## Updated Product Change Notification Software Release Notice

### mPower™ Edge Intelligence Software mPower 5.3.0

## MultiConnect® rCell 100 Series Cellular Routers

**Product Change Notification (PCN) Number**  
PCN 12142020-002 (mPower - MTR)

**API Command Changes (MTR 5.3.0):**

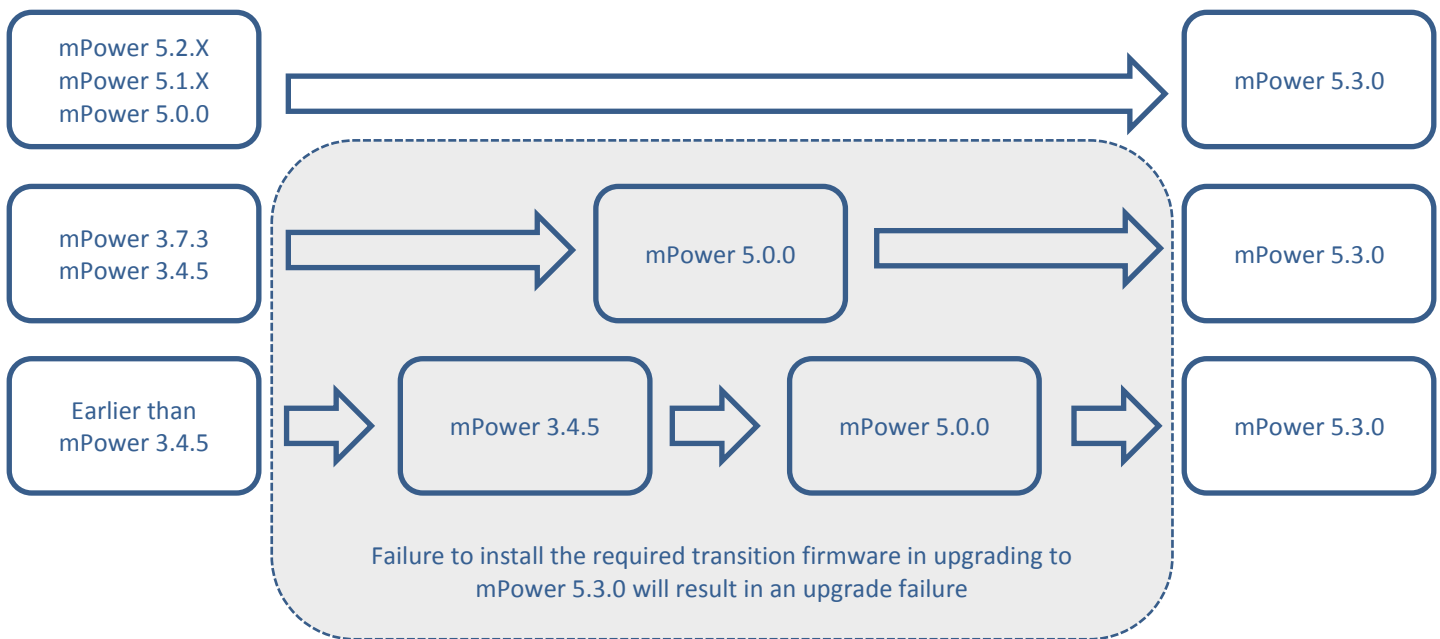
The MultiConnect rCell 100 Series Router uses the RESTful JSON API for managing configurations, polling statistics, and issuing commands. mPower MTR 5.3.0 versions include a number of API changes.
